Re: Variance Request – Eaton Sugar Beat Factory (Work Area 3A), CO Section III.W.

Regulation No. 8, Part B Variance Request Form

Subject: **Eaton Sugar Beet Factory, Structural Recommendations No. 2**

The variance request for Eaton Sugar Beat Factory (Work Area 3A), CO Section III.W., has been **DENIED** based on your submittal, due to the following:

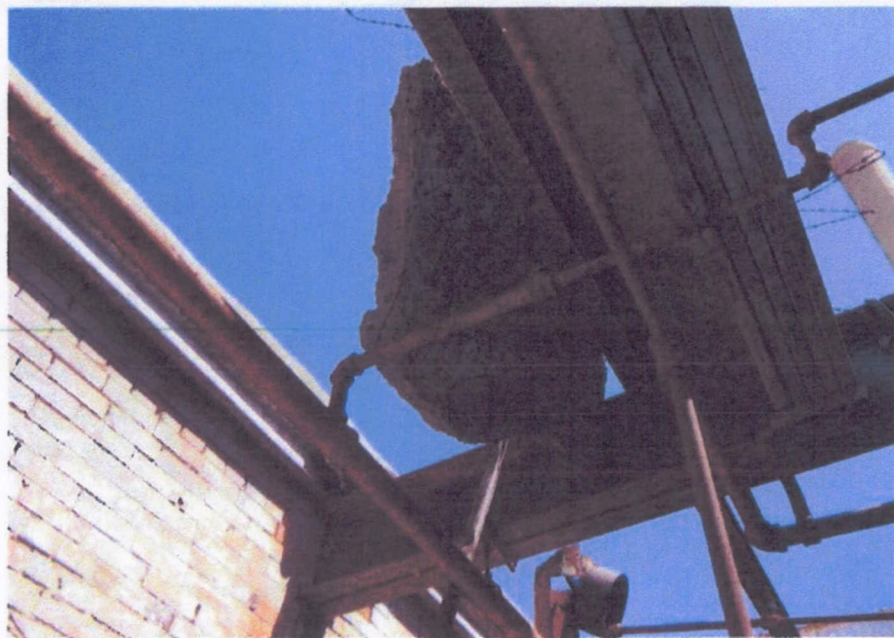
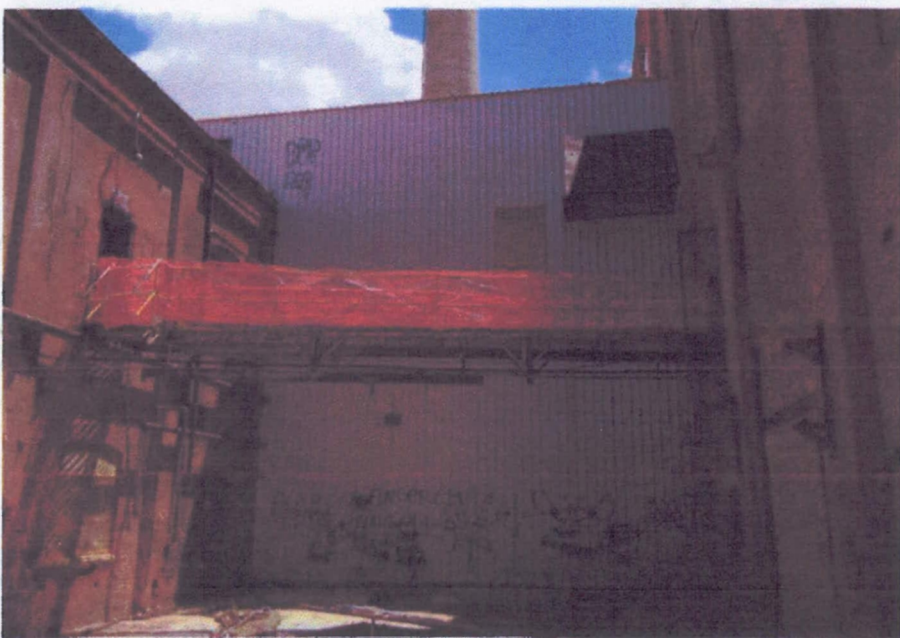
Zone 3a, adjacent to Zone 2, was observed due to concern about the roof structure and its supporting masonry wall. The wall in question is at the south end of Zone 3a, and abuts the metal building framing of Zone 2. As shown in the photograph below, this load bearing wall is supporting the steel beams which support the concrete roof deck.

Zone 3a is very unstable and should be considered structurally unsound. Implementation of abatement work may endanger personnel who will be removing asbestos from the facility. Additional load and vibrations on or near this wall may result in collapse of the wall which is already partially collapsed and leaning into Zone 2. Temporary shoring should be located under each steel roof beam, and continued below the floor to the slab on grade in Zone 3 below, before any work is done in this area. Care should be taken when working in this area to ensure that personnel are in Zones 2 and Zone 3 are not injured should the wall collapses and drop bricks below.

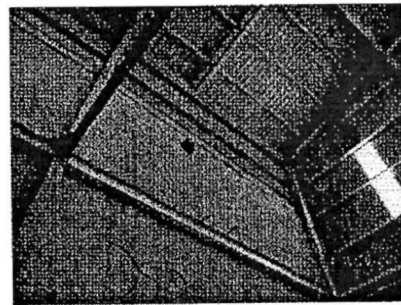
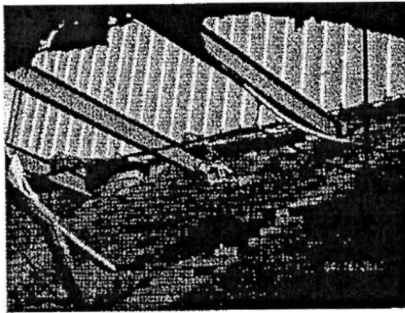
~~Zone 3a of the Kiln Building, adjacent to Zone 2 of the East Metal-Sided Boiler Building,~~ ^{Remove} was observed due to concern about the roof structure and its supporting masonry wall. The wall in question is at the south end of Zone 3a, and abuts the metal building framing of Zone 2. As shown in the photograph below, this load bearing wall is supporting the steel beams which support the concrete roof deck. ^{Remove}

Zone 3a is very unstable and should be considered structurally unsound. Implementation of abatement work may endanger personnel who will be removing asbestos from the facility. Additional load and vibrations on or near this wall may result in collapse of the wall which is already partially collapsed and leaning into Zone 2. Temporary shoring should be located under each steel roof beam, and continued below the floor to the slab on grade in Zone 3 below, before any work is done in this area. Care should be taken when working in this area to ensure that personnel are in Zones 2 and Zone 3 are not injured should the wall collapses and drop bricks below.
